CSP 26-006AL (BP030) – ADDENDUM No.01
Willowridge HS Renovations

Fort Bend Independent School District
2023 Bond Program

addendum

PROJECT BP030 Willowridge High School Fine Arts Addition and Renovation, 2023306
PROJECT NO. CSP 26-006AL
ADDENDUM NO. 001
BID PACKAGE ISSUE FOR BID AND PERMIT

1 LEVEL 1 ELECTRICAL DEMOLITION FLOOR PLAN - AREA B2
1/8" = 1'-0"

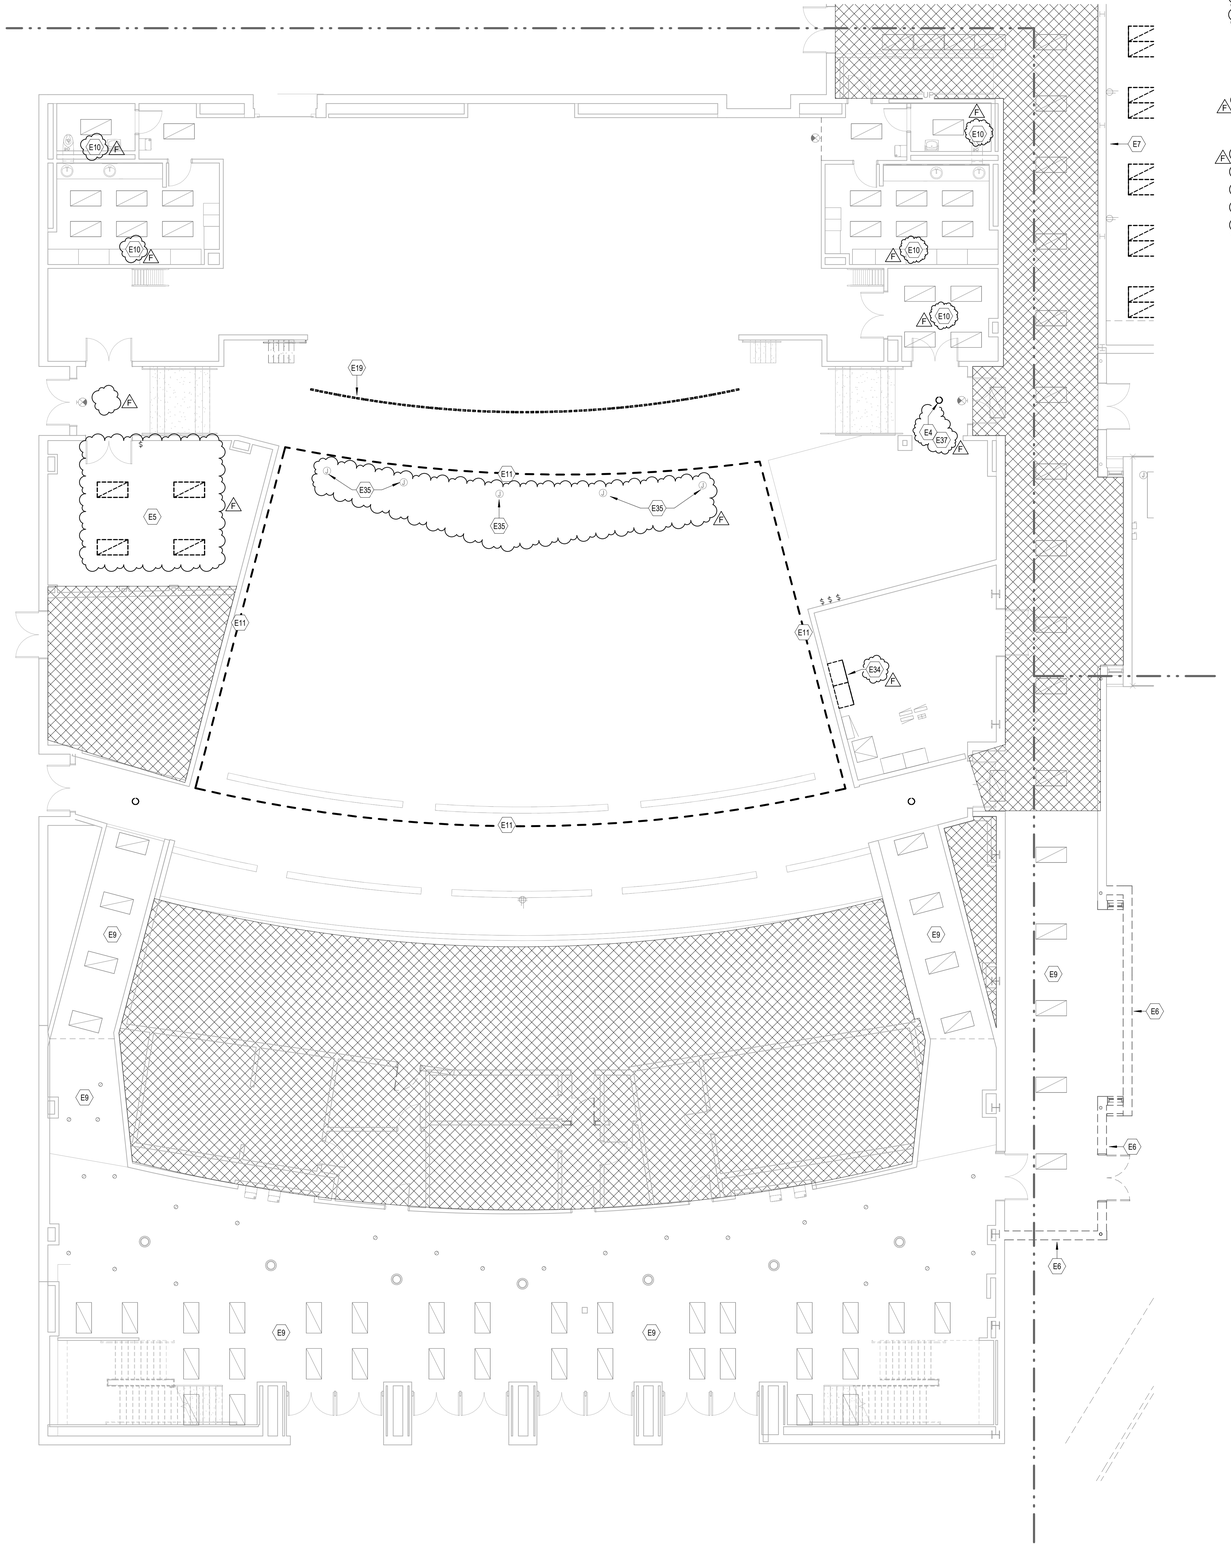
E2.14 LEVEL 1 ELECTRICAL DEMOLITION PLAN – AREA B2

1. Existing lights in scene shop clarified to be removed and replaced, tagged note E5 added to sheet. .
2. Tagged note E10 added to sheet to clarify rooms existing to remain.
3. Tagged notes E4, E34, and E37 added to sheet.
4. Existing power locations for lower level seat lighting shown. Tagged note E35 added to sheet.

1 LEVEL 2 ELECTRICAL DEMOLITION FLOOR PLAN - AREA B2
1/8" = 1'-0"

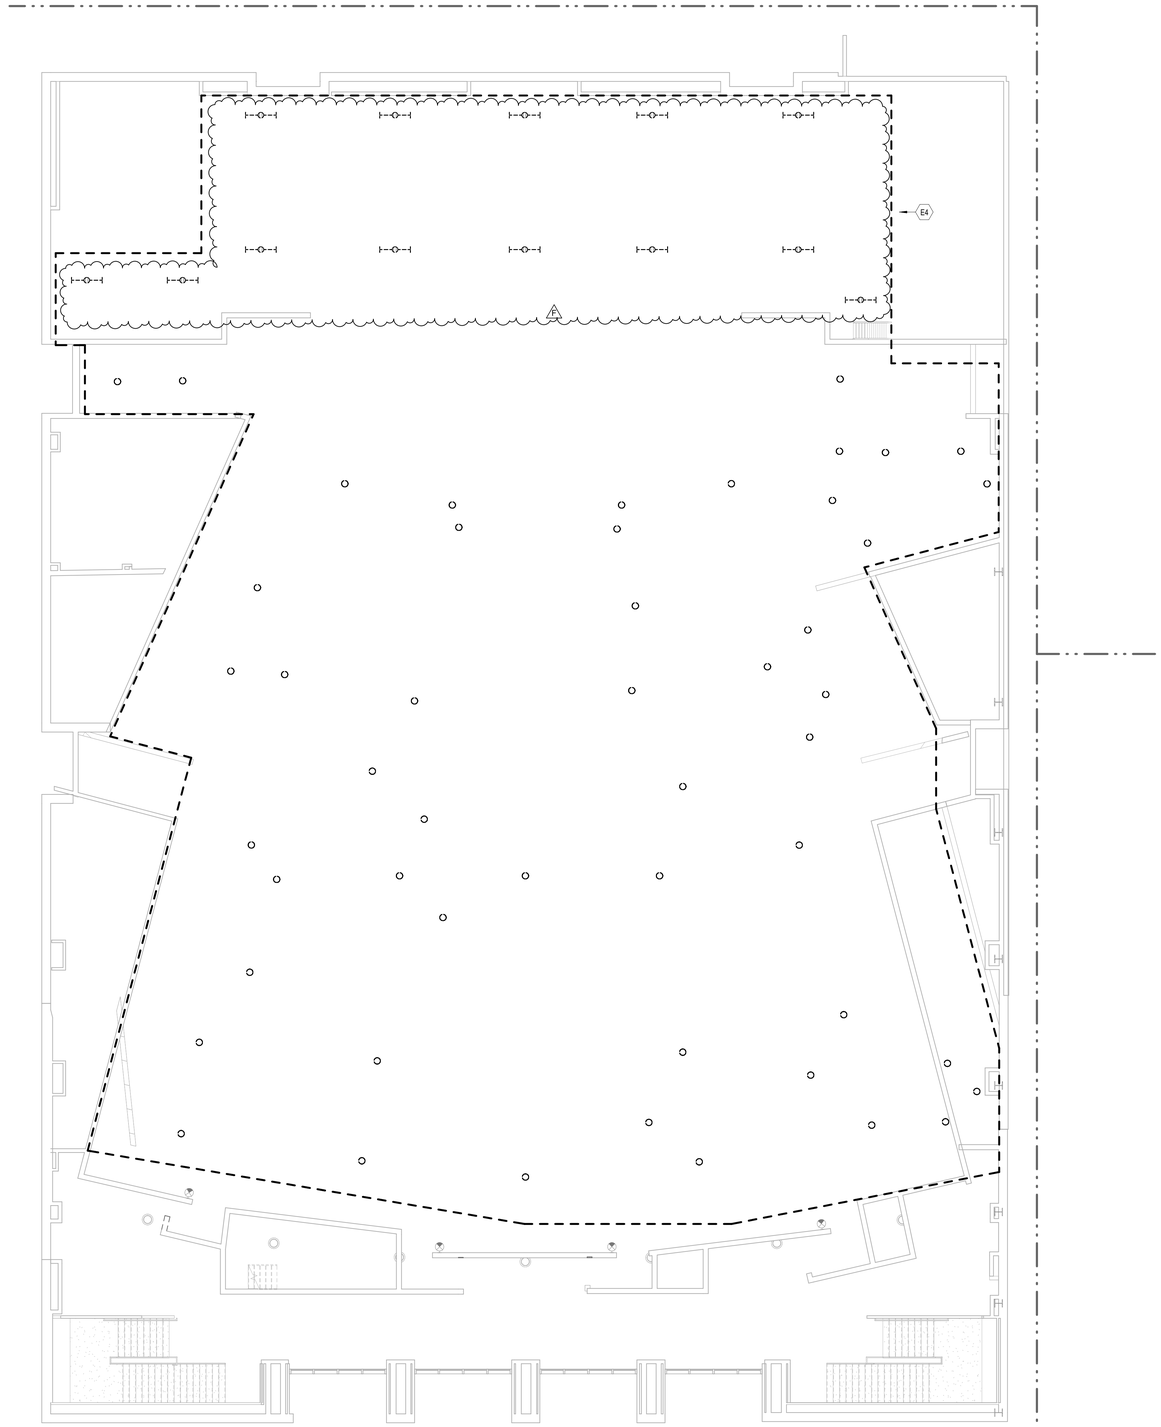
E2.17 LEVEL 2 ELECTRICAL DEMOLITION PLAN - AREA B2

1. Existing back of house light fixtures on stage revised from cylinder pendants to strip lights for clarity. Tagged note E4 modified as shown.

1 LEVEL 2 ELECTRICAL DEMOLITION FLOOR PLAN - AREA B2 - ALTERNATE
1/8" = 1'-0"

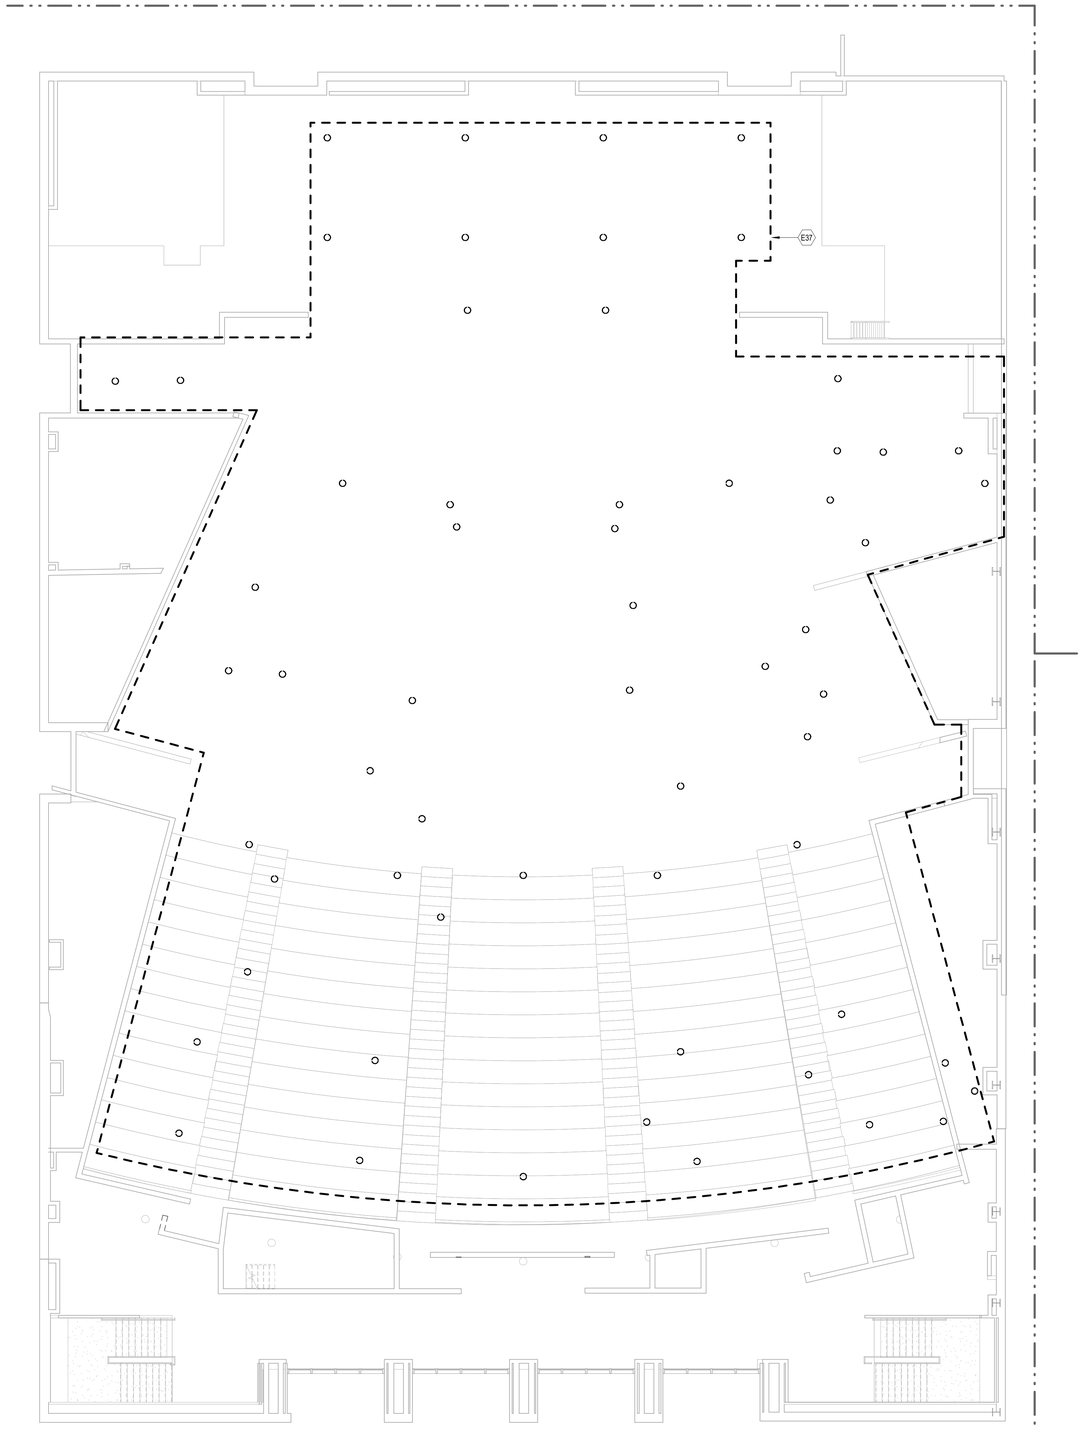
E2.17.A LEVEL 2 ELECTRICAL DEMOLITION PLAN - AREA B2 - ALTERNATE

1. Tagged note E37 modified to update alternate number.

E2.19 LEVEL 2 ELECTRICAL DEMOLITION PLAN - ART ROOMS & MECH SPACES

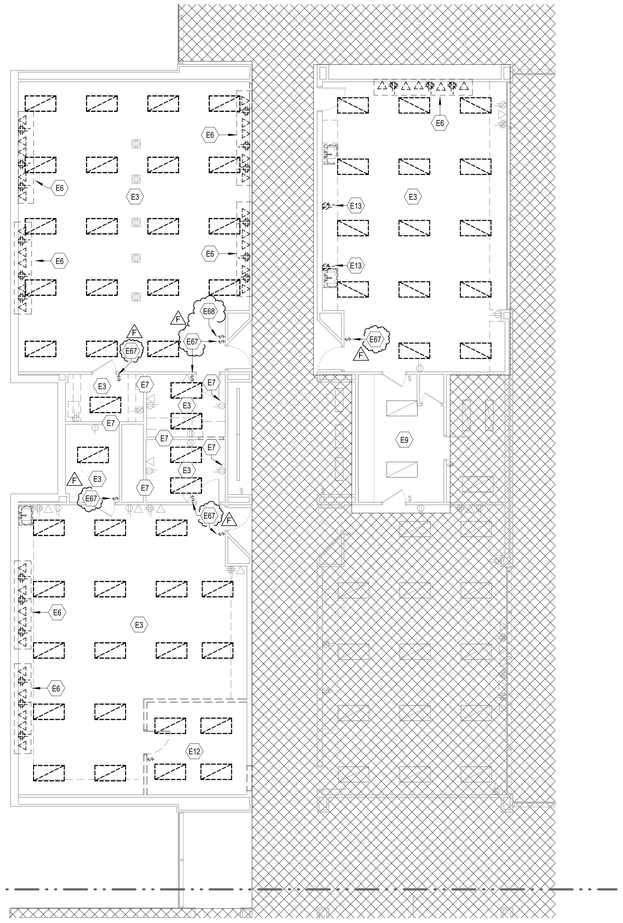
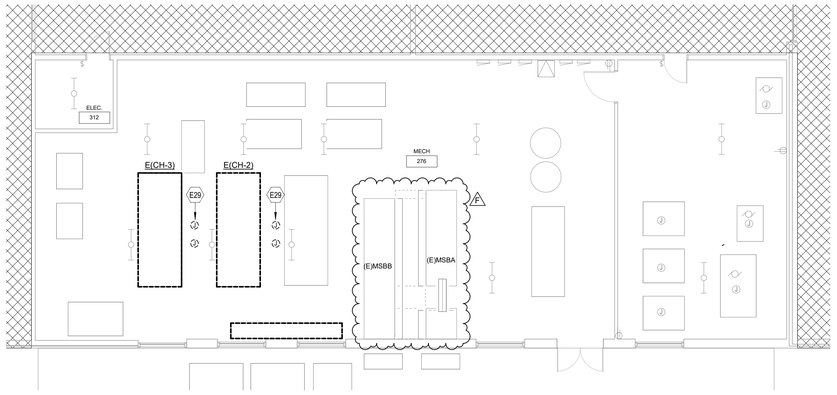
1. Tagged note E29 modified to remove alternate verbiage.
2. Existing MSBA and MSBB clarified as existing to remain.
3. Tagged note E67 and E68 added to sheet to clarify locations for switches to be removed and replaced.

SHEET NUMBER
E2.21

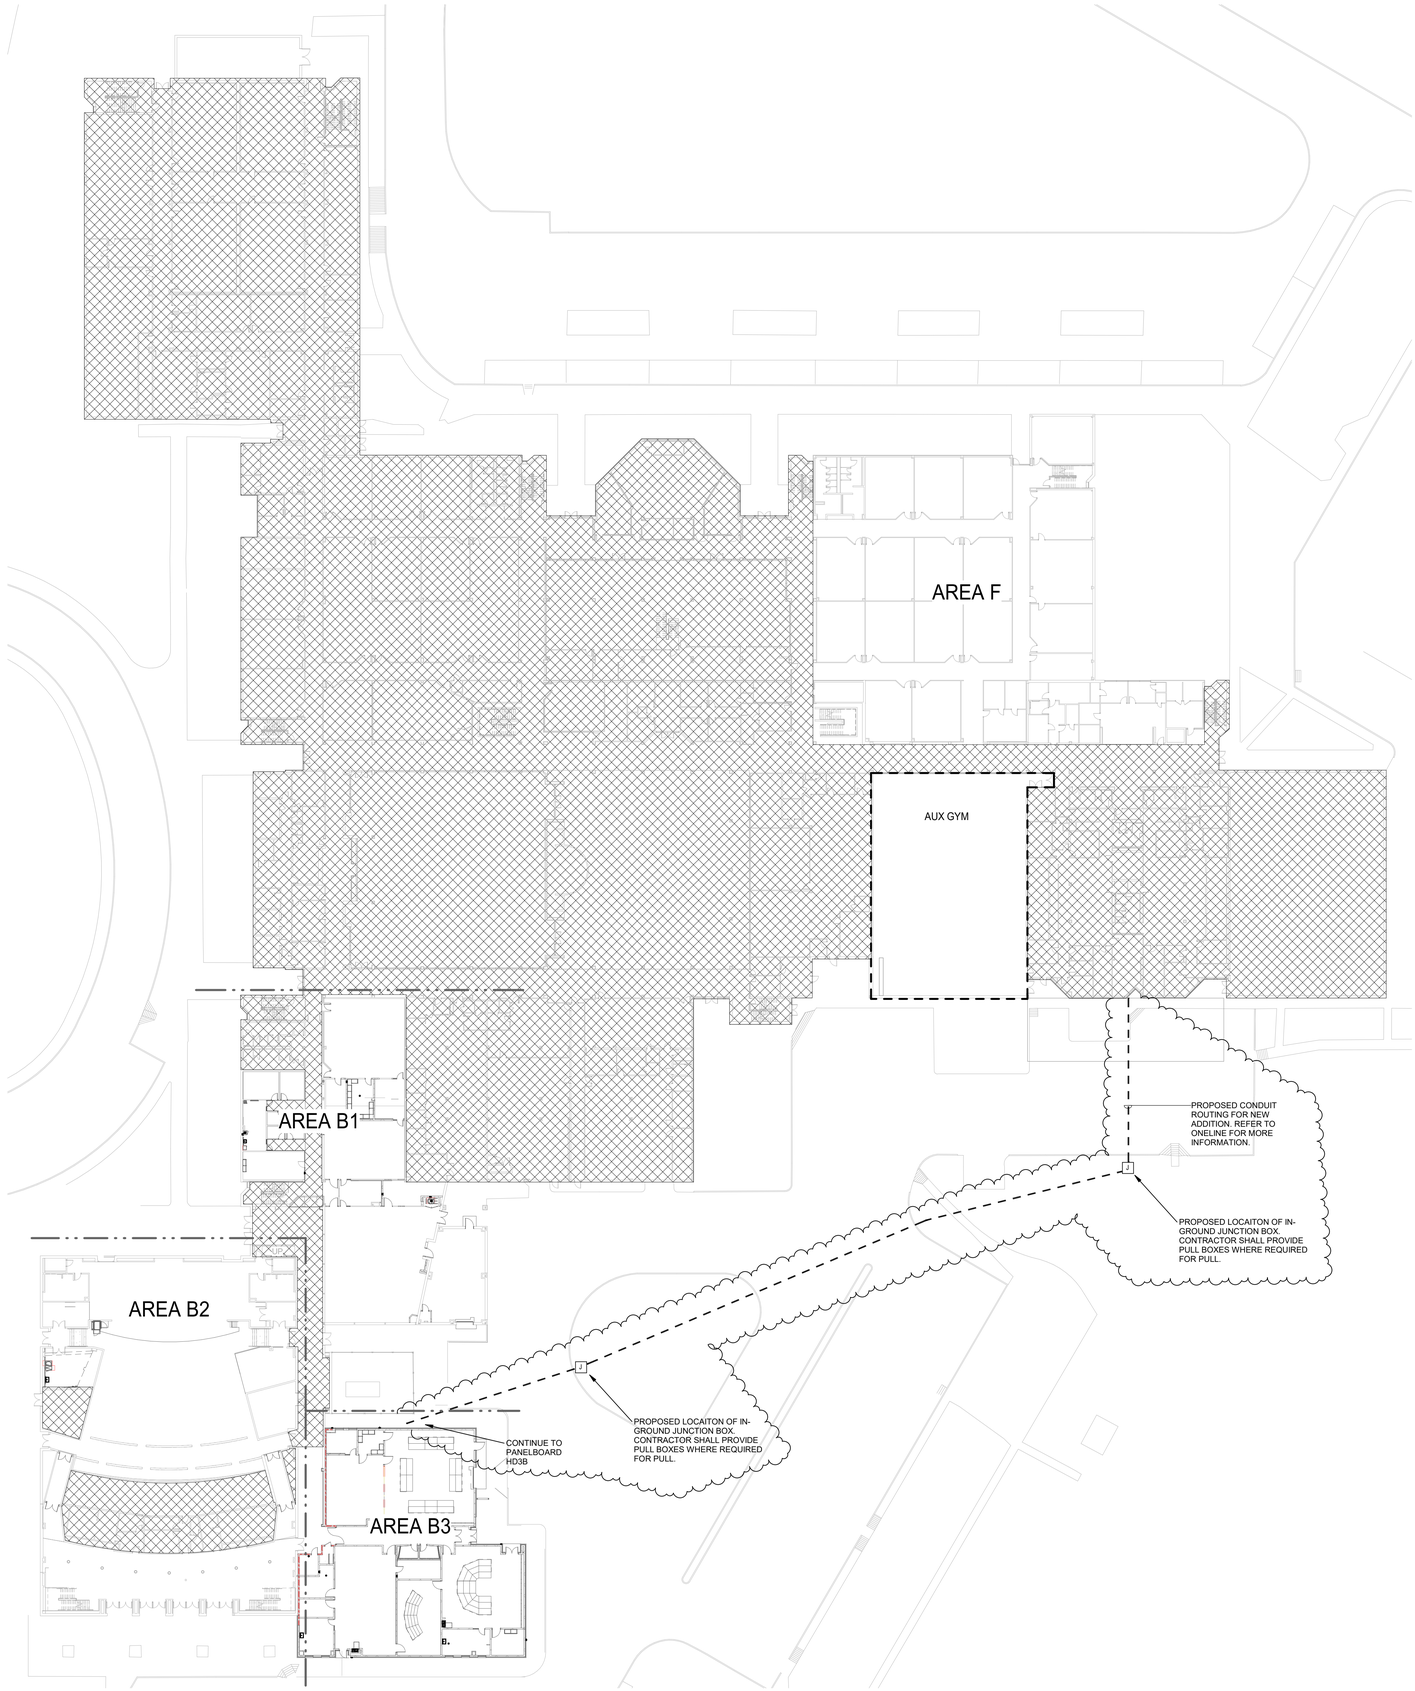
E2.21 LEVEL 1 OVERALL PLAN – ELECTRICAL

1. Added proposed routing for feeder to new building.

1 LEVEL 1 - POWER FLOOR PLAN - AREA B1
1/8" = 1'-0"

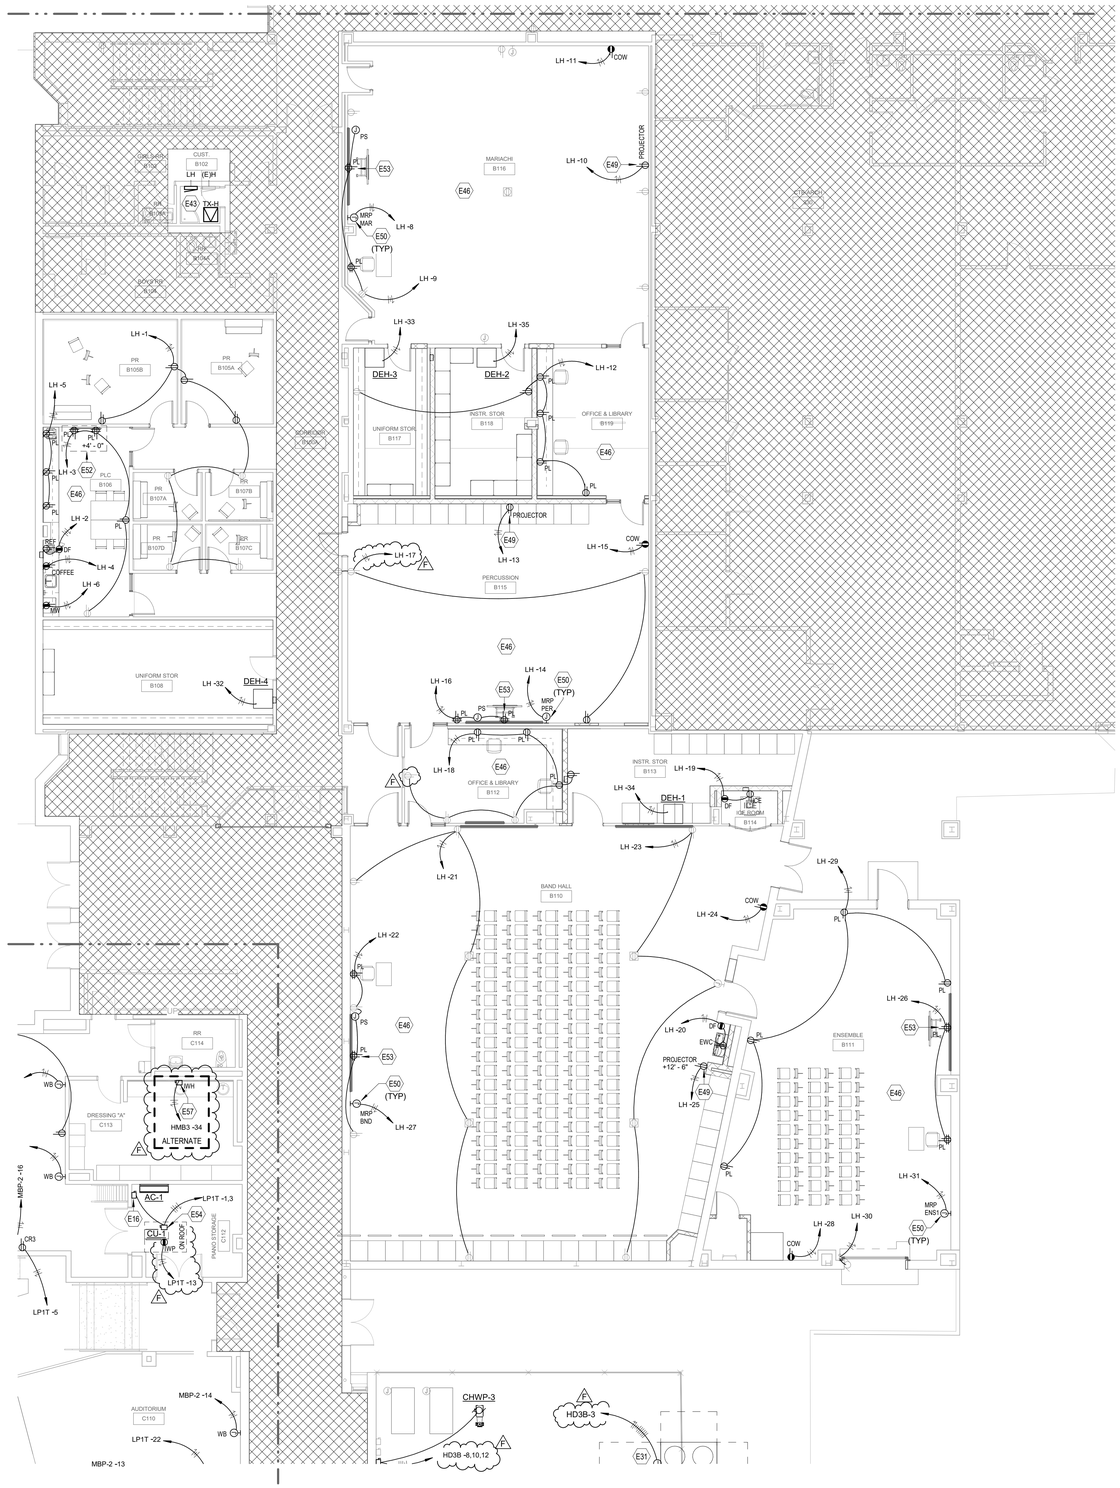
E2.31 LEVEL 1 POWER FLOOR PLAN – AREA B1

1. Existing duplex in B112 Office revised to remain and recircuited to new panel.
2. Homerun shown for circuit in B115 Percussion.
3. View #3 renamed as 'ALTERNATE 5'. Tagged note E32 removed and replaced with E62. Tagged note E63 added to view to clarify disconnect size. Controls for ACCH-3AT and ACCH-4ALT circuited to panel LP1T.
4. In View #4 tagged note modified for CHWP-3 disconnect to E64. Controls for ACCH-4 circuited to panel LP1T.
5. Change circuit for the chillers.
